RE: Constitution Storage Development; Full Spectrum Detention Pond Certification

Please accept this letter as formal documentation of conformance of the Full Spectrum Detention Pond (Pr. FSD-1) for stormwater quality and detention at the Constitution Storage Development. The Constitution Storage Development (Site) is located at 2460 Canada Drive, Colorado Springs within El Paso County, Colorado. The project site is located south of Constitution Avenue, west of Canada Drive, & east of Peterson Road. The site is located in a portion of Section 05, Township 14 South, Range 65 West of the 6th Principal Meridian, County of El Paso, State of Colorado.

DETENTION BASIN OUTLET STRUCTURE DESIGN

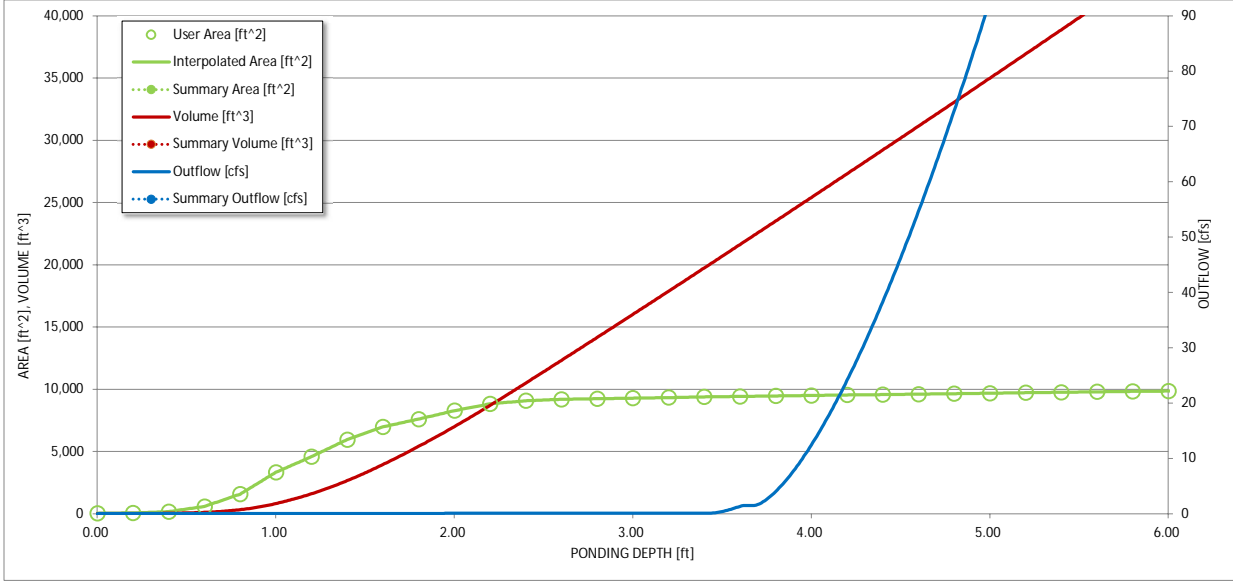
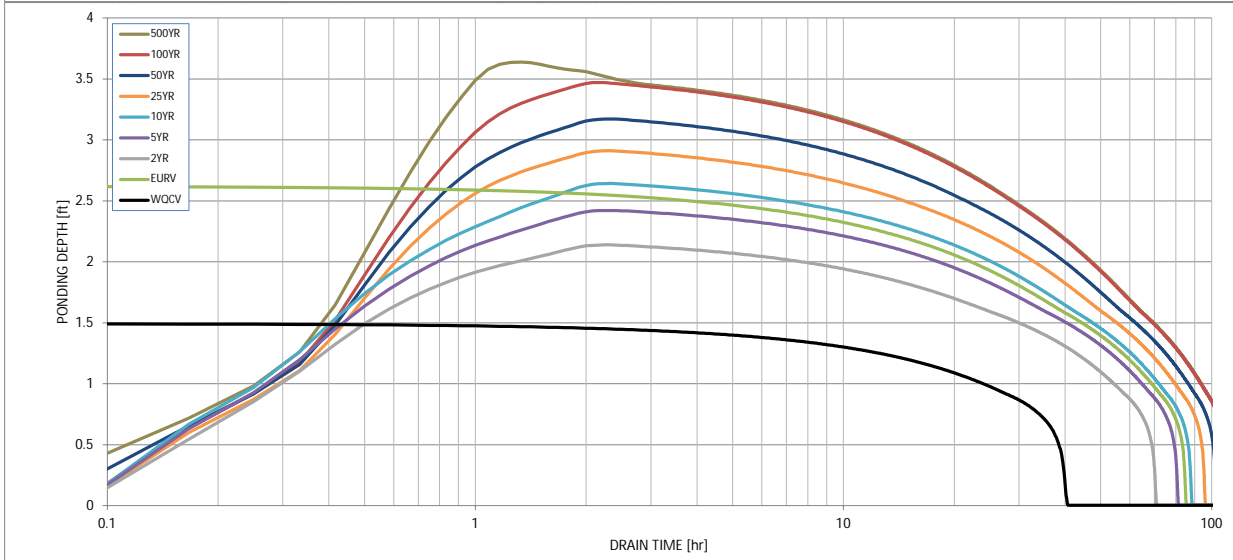
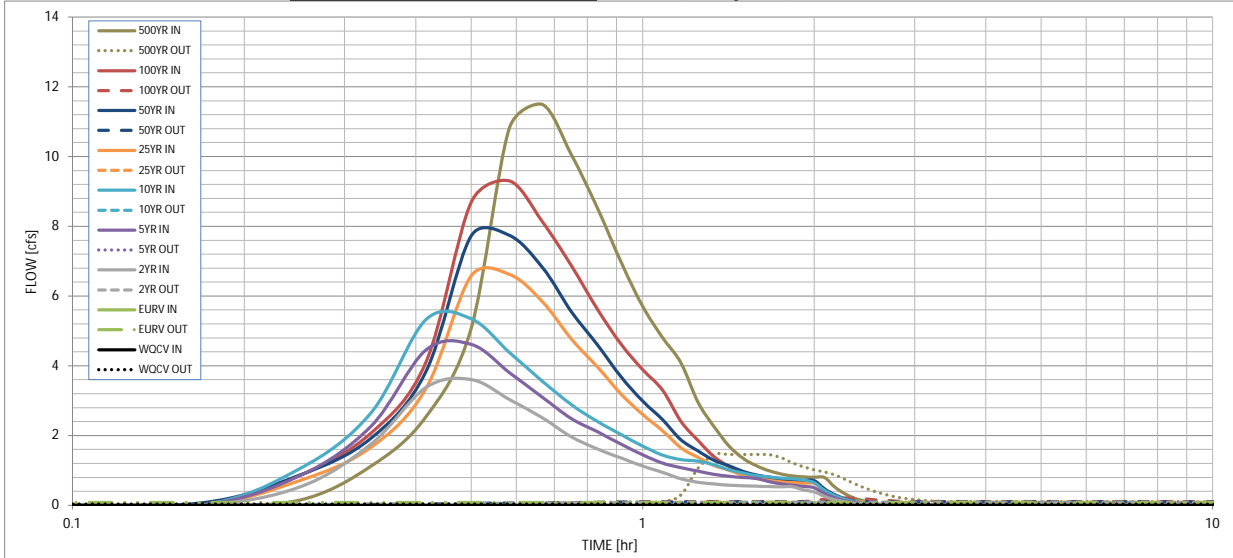
PPR2343 called for an 8" pipe.
Please confirm **APPROVED PLANS SHOW 12" HDPE PIPE**

OVERALL PCM PLAN

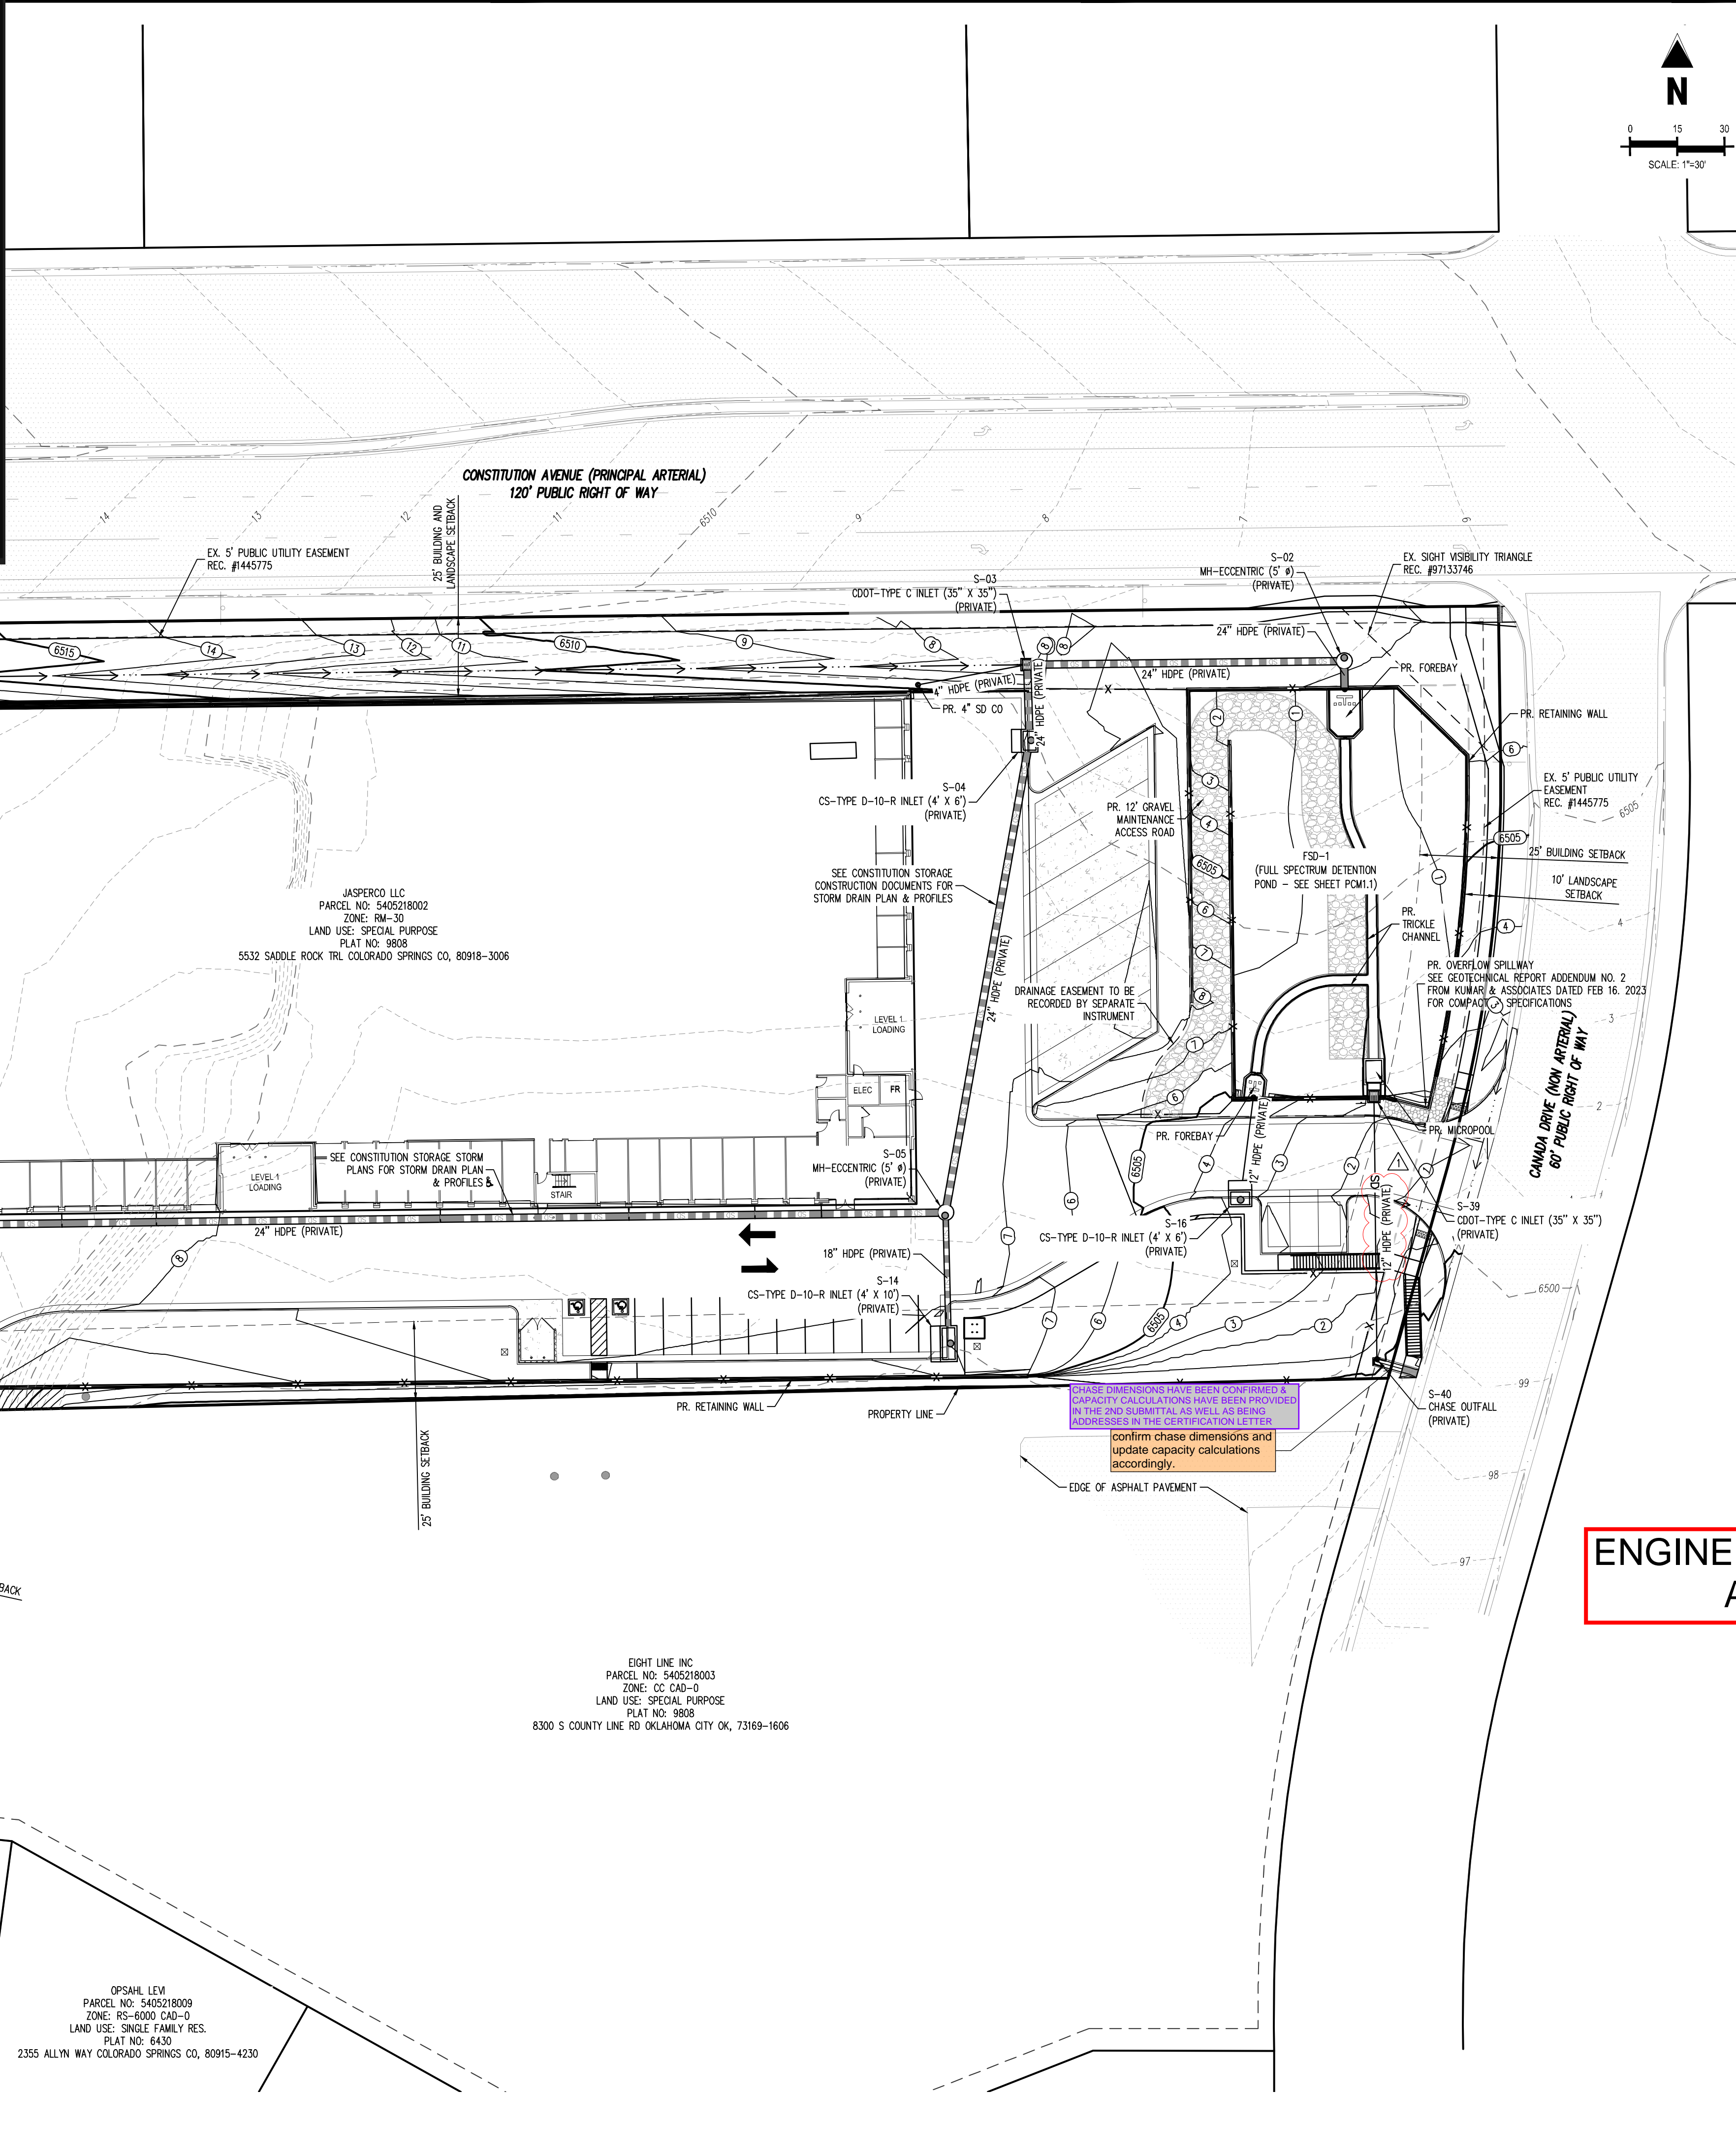
SWALE ELEVATIONS HAVE BEEN REVISED BY THE GENERAL CONTRACTOR (GG&C) & CURB CUT HAS BEEN INSTALLED.
confirm swale elevations and curb cut installation

3 SOUTH FOREBAY SLOT DETAIL
SCALE: 1"=5'

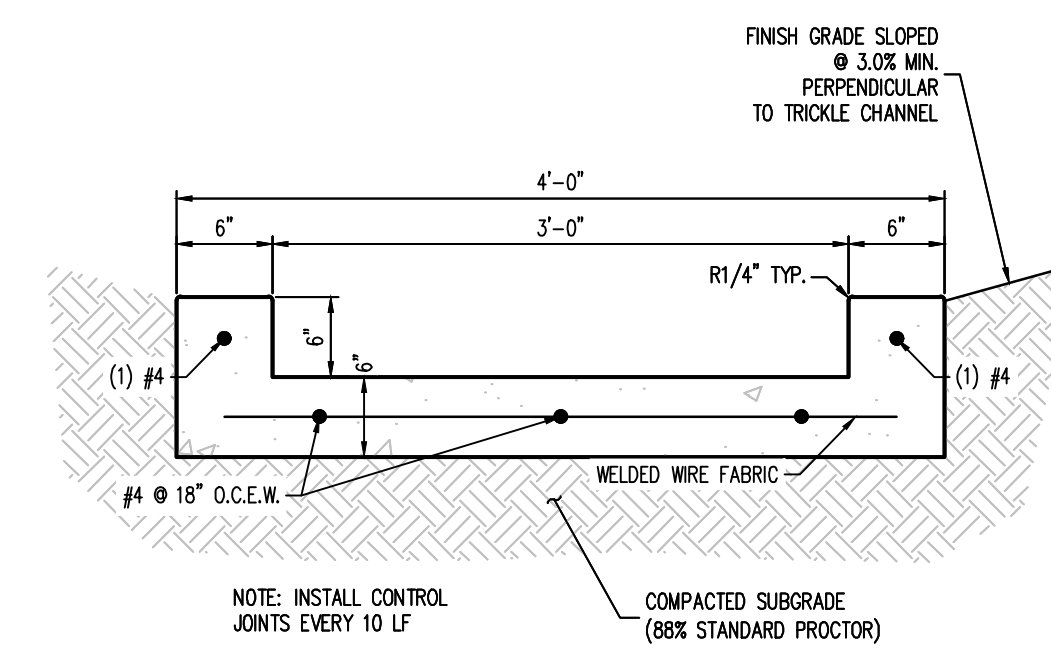
confirm forebay notch size and provide updated calculations

SOUTH FOREBAY SLOT SIZING APPEARS TO MEET DESIGN (1.7' DESIGN vs. 3.75' AS-BUILT)
